**Harbourside Shopping Centre Redevelopment SSD-7874
Amended Concept Proposal and Stage 1 Early Works October 2020 and
Response to submissions**

My submission is to OBJECT based on the grounds that the minor changing to the northern podium do not :

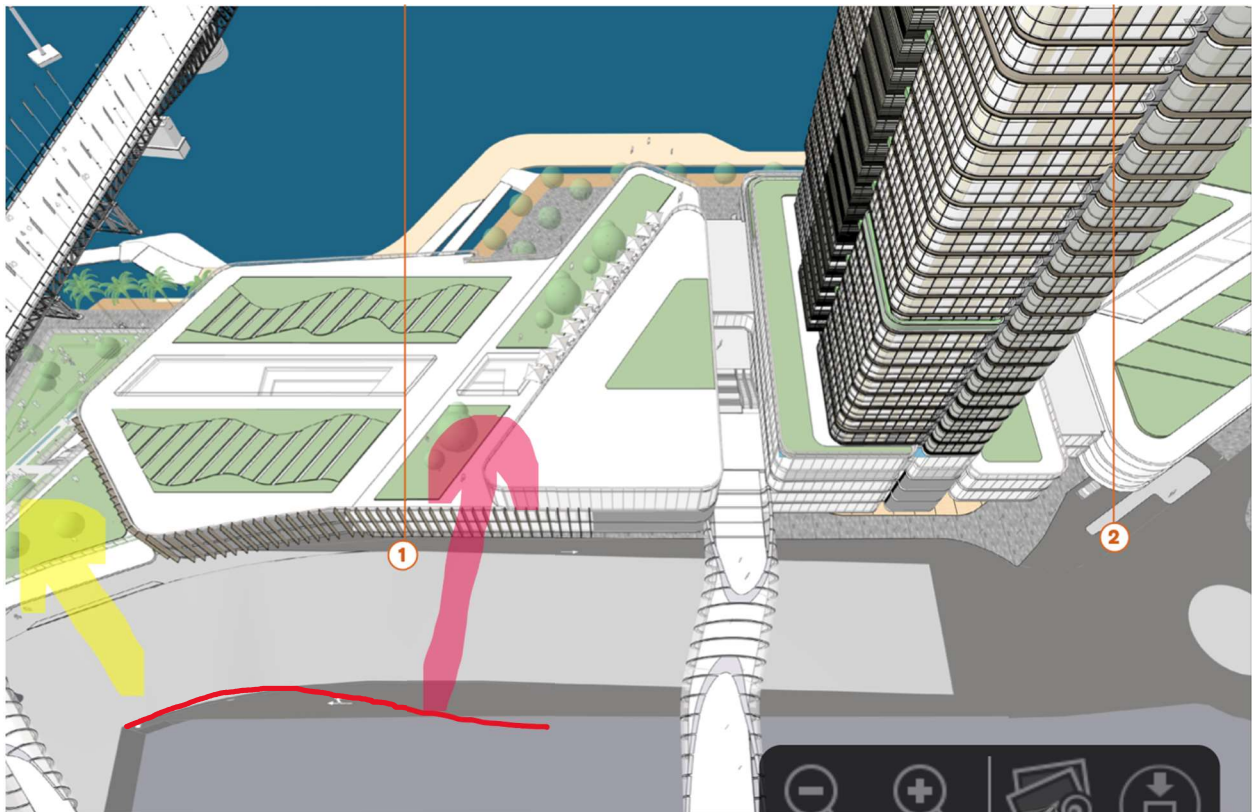
The majority of the **east facing** apartments of 50 Murray Street have highly valued views that enjoy **whole water views of Cockle Bay**. Every aspect (Floor to ceiling glass) of the apartments, in addition to the balcony, have a view of the water. With the previous concept, all east facing apartments at level 8 and below totally lost all Cockle Bay views. The amended concept as shown below still has east facing apartments losing all Cockle Bay water views.

Views from curved 50 Murray Street are inconsistent with the provision of a channel view platform to the north east claiming to have 'significantly improved view sharing of 50 Murray Street'

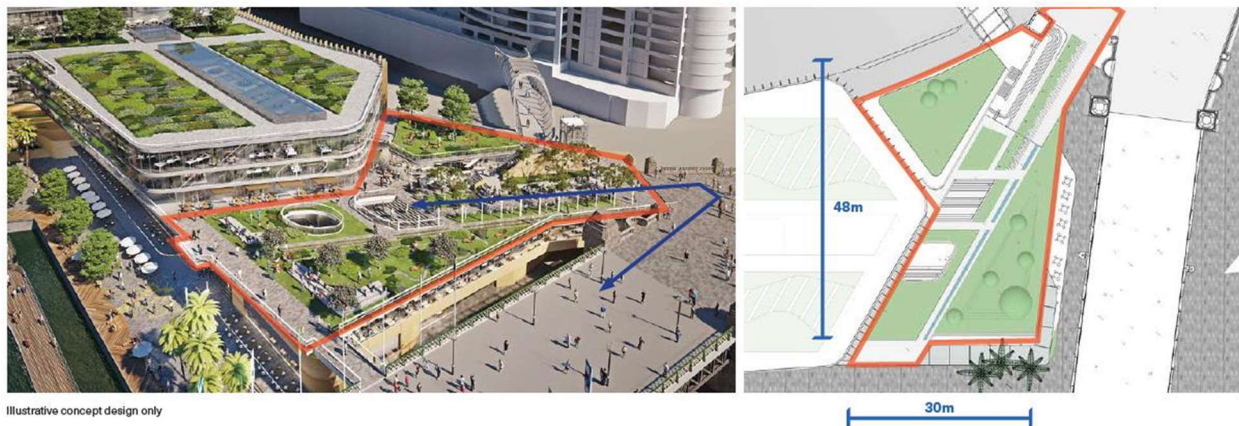
The proponent claims that by introducing a north east facing 'channel' it provides views north of Pyrmont Bridge and thus claims it has '*significant improved view sharing of 50 Murray Street*'. This is an **unacceptable claim**. It has been pointed out that east faced of 50 Murray Street is a curved. Providing a north east channel at the north end of the proposal has no impact on sharing the water views of Cockle Bay.

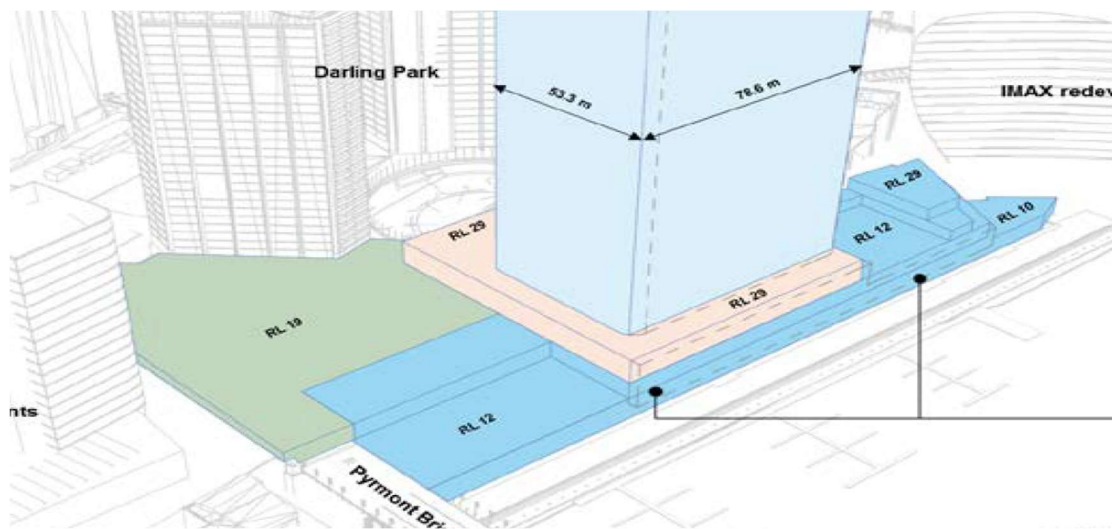
Options for Concept change to provide the proponent with the same development potential and reduce the impact on the loss of water view of 50 Murray Street and the impact on the State listed Pyrmont Bridge.

- Sharing of views of Cockle Bay particularly from 50 Murray street; and
- the character of the precinct and the consistency of the experience and vibrancy of Cockle Bay as well as its various landmarks particularly heritage elements such as the Pyrmont Bridge it is recommended to amend the proposed envelop for the northern portion of the podium to maintain the RL 13.75, but extend the RL 17.60 such that it extends 85m from Pyrmont Bridge. Such an outcome would negate or objection.

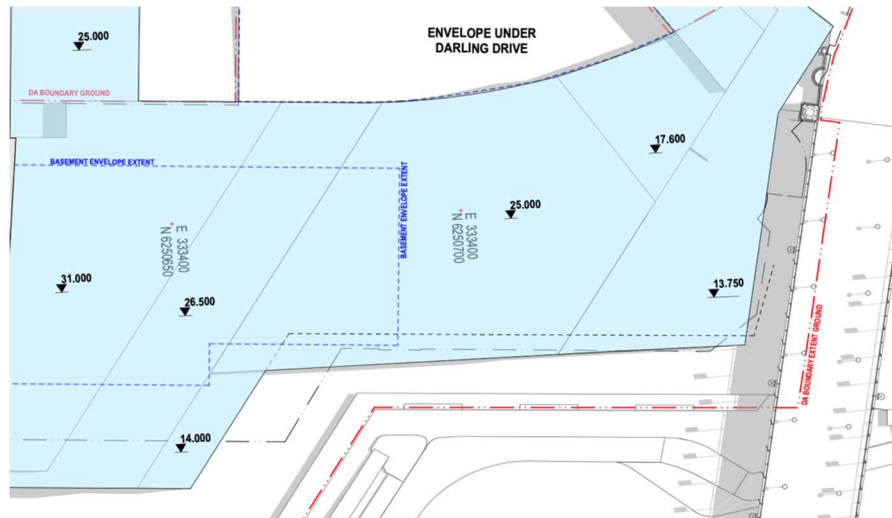
In contrast, the Harbourside Shopping Centre Redevelopment proposal is for a two level park RL's of 13.75 and RL 17.6 extending away from the Pymont Bridge by only some 30m before rising to 25, proposing and RL of for the northern portion of the podium rising to RL 26.5 and then RL31.

The impact of approving the envelop for the Harbourside Shopping Centre Redevelopment will produce two inconsistent character of addressing the Cockle Bay basin as well as an inconsistent start and end of the Pyrmont Bridge.
